Objection to Advertisement Application PL/2026/03738

Cannings Hill Garage, Horton Road, Devizes, SN10 2JG

Proposed site signage, including digital menu boards, banner unit, Play Land sign and operational signage

Objector: Paul Howlett

Figure 1 — Plan of the proposed PL/2026/03738 site signage in relation to Elder and the A361/Horton Road roundabout.

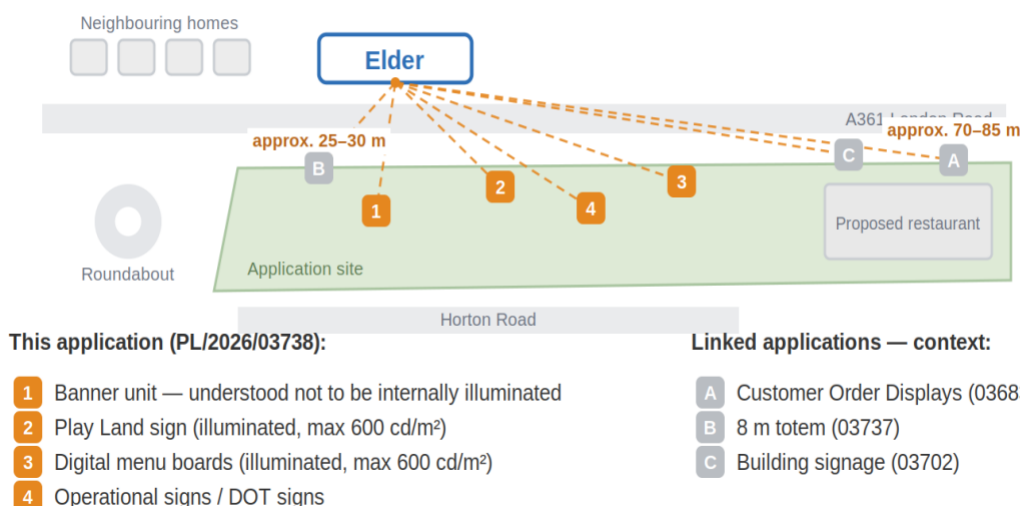
The approximate distances from the nearest visible part of Elder's residential façade demonstrate that the proposed signage is not remote from residential receptors:

Note: distances are approximate and scaled from the applicant's drawings, not surveyed dimensions. These relationships are illustrated in Figures 1 to 3 and addressed in Sections 3, 6, 10 and 11.

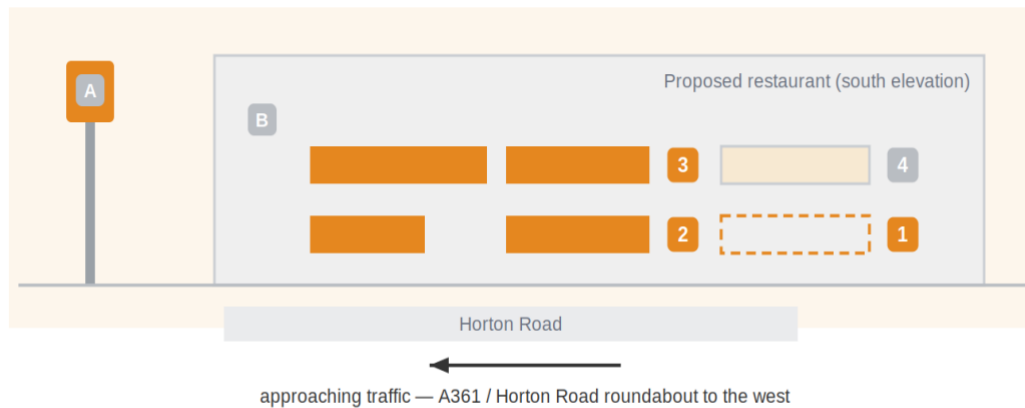
There is also a public-safety objection. The signage would be viewed close to the A361/Horton Road roundabout, the proposed site access, pedestrian crossing points, highway signage and the national speed-limit terminal. Drivers would be required to process digital displays, operational instructions, promotional signage, illuminated branding, vehicle movements and pedestrian activity in the same visual environment.

Figure 3 — Indicative composite section showing the relationship between the first-floor bedroom/en-suite window at Elder, the 1.1 m Elder-facing close-boarded "headlight screen", and the principal PL/2026/03738 signage elements. Heights and positions are illustrative.

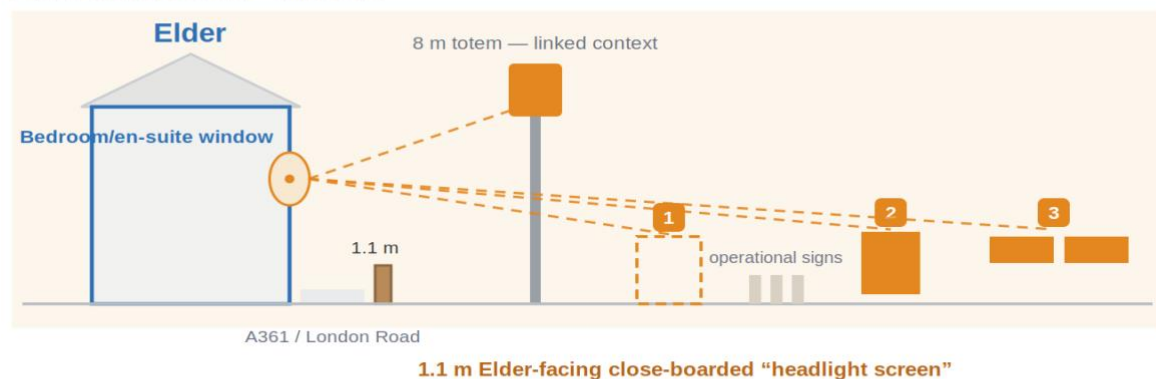
The Play Land sign requires particular scrutiny. It is internally illuminated, stated at a maximum luminance of 600 cd/m², and appears to sit within the line of view from the first-floor bedroom/en-suite at Elder.

The relevant Elder-facing boundary is shown on the applicant's Site Layout Plan as a 1.1 m close-boarded "headlight screen", which cannot reasonably be assumed to protect elevated residential windows from the cumulative illuminated signage environment. Figure 3 illustrates that relationship.

Sight lines from the first-floor bedroom/en-suite window pass over the 1.1 m ground-level screen.
Linked elements shown for cumulative context only.

That matters in this location because the Play Land sign appears to sit within the line of view from the first-floor bedroom/en-suite at Elder, as illustrated in Figure 3. It should therefore not be assessed only from ground level or from within the restaurant site. Its residential effect should be assessed from elevated residential windows facing the site across the A361.

Because the relevant accommodation at Elder is at first-floor level, boundary fencing and ground-level planting cannot be assumed to screen the Play Land sign or its illumination. Even if the sign is lower than the 8-metre totem, it would still form part of the illuminated signage environment visible from the residential frontage.

If consent is granted, the Play Land sign should be switched off outside approved Play Space hours. Any restriction on the operation of the Play Space itself should be secured, if necessary, under the main planning application rather than through advertisement consent.
